Two proposals for priority based PLCA

Sungkwon Park

Hanyang University, Seoul, Republic of Korea

Figure 148-5 PLCA DATA state Diagram

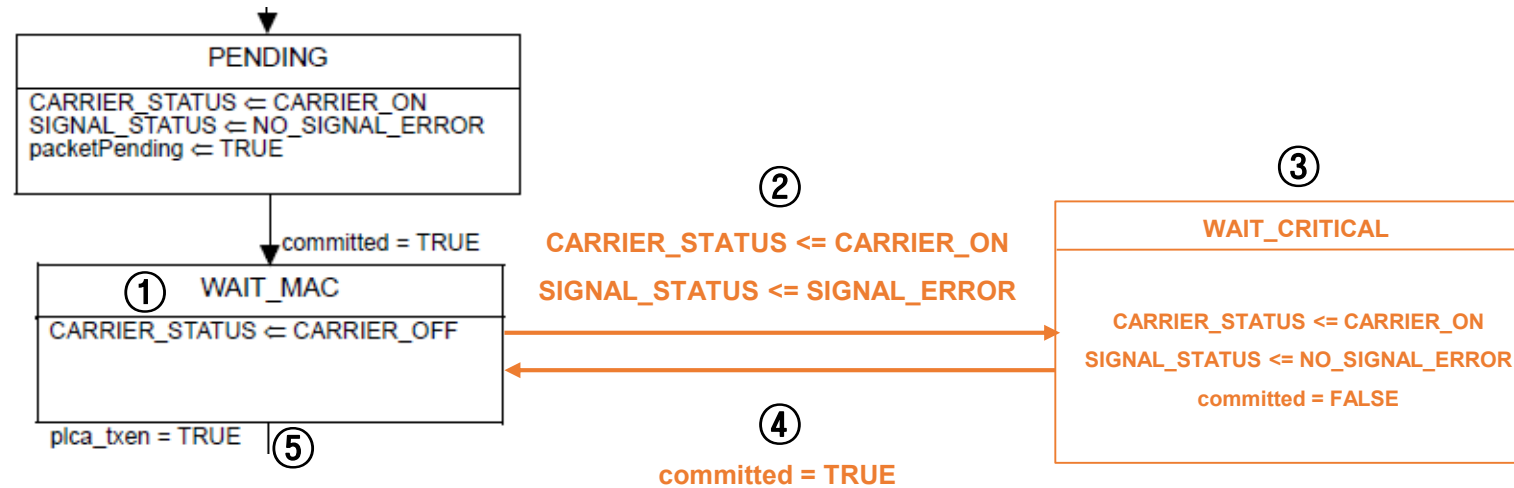
3. Changes to PLCA DATA state Diagram

- Figure 148-5 shows the state diagram of the operation of the node with the transmission opportunity.

1) **WAIT_MAC** = IDLE time

3. Changes to (continued) PLCA DATA state Diagram

- 2) When an ALARM signal is received, the **CARRIER_STATUS** is in the **CARRIER_ON** state to transmit CRITICAL DATA and the **SIGNAL_STATUS** becomes the **SIGNAL_ERROR** state to enter **WAIT_CRITICAL**.
- 3) After entering the **WAIT_CRITICAL** state (CRITICAL DATA transmission), the state of the node having the transmission opportunity recognizes the transmission of the CRITICAL DATA through **CARRIER_STATUS <= CARRIER_ON** and waits (**committed = FALSE**).
- 4) After CRITICAL DATA transmission is completed, the waiting node acquires the transmission opportunity again (**committed = TRUE**).
- 5) The waiting node have an IDLE time and start to transmit DATA.

But when an ALARM signal is received, the CARRIER_STATUS is in the CARRIER_ON state to transmit CRITICAL DATA and the signal status becomes the SIGNAL_ERROR state to enter WAIT_CRITICAL. After entering the WAIT_CRITICAL state (CRITICAL DATA transmission), the state of the node having the transmission opportunity recognizes the transmission of the CRITICAL DATA through $CARRIER_STATUS \leq CARRIER_ON$ and waits (committed = FALSE). After CRITICAL DATA transmission is completed, the waiting node acquires the transmission opportunity again (committed = TRUE). The waiting node have an IDLE time and start to transmit DATA.

Figure 148-4 PLCA CONTROL state Diagram

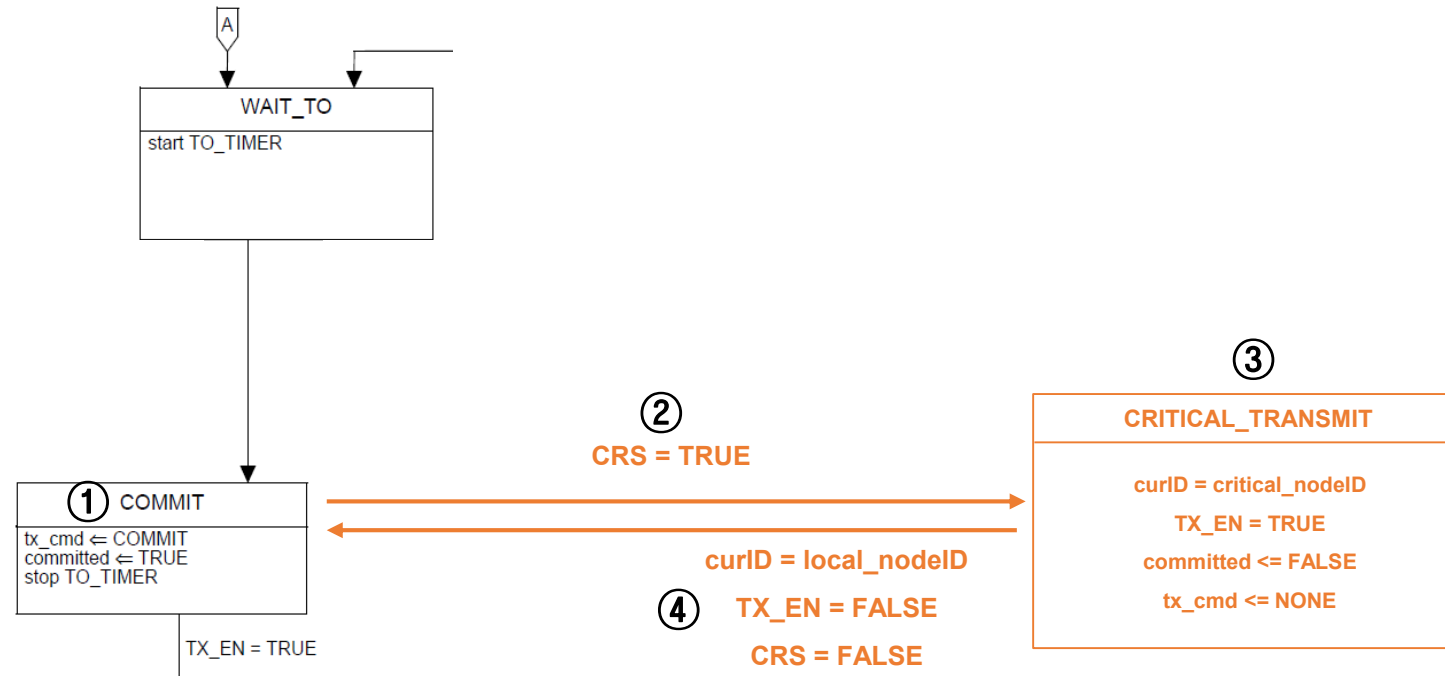
3. Changes to PLCA CONTROL state Diagram

- 1) It is IDLE time of a low priority node.
- 2) An ALARM signal has been detected (**CRS = TRUE**).

3. Changes to PLCA CONTROL state Diagram

- 3) The transmission opportunity is passed to the node that generated the ALARM signal (`curID = critical_nodeID`). The node with the previous transmission opportunity stores the transmission sequence number using the `local_nodeID` variable.
- 4) When the transmission of the critical data is completed, the transmission opportunity is returned to the original node (`curID = local_nodeID`) and the regular PLCA transmission cycle is continued.

When an ALARM signal has been detected ($CRS = TRUE$), the transmission opportunity is passed to the node that generated the alarm signal ($curID = critical_nodeID$). The node with the previous transmission opportunity stores the transmission sequence number using the $local_nodeID$ variable. When the transmission of the critical data is completed, the transmission opportunity is returned to the original node ($curID = local_nodeID$) and the regular PLCA transmission cycle continues.
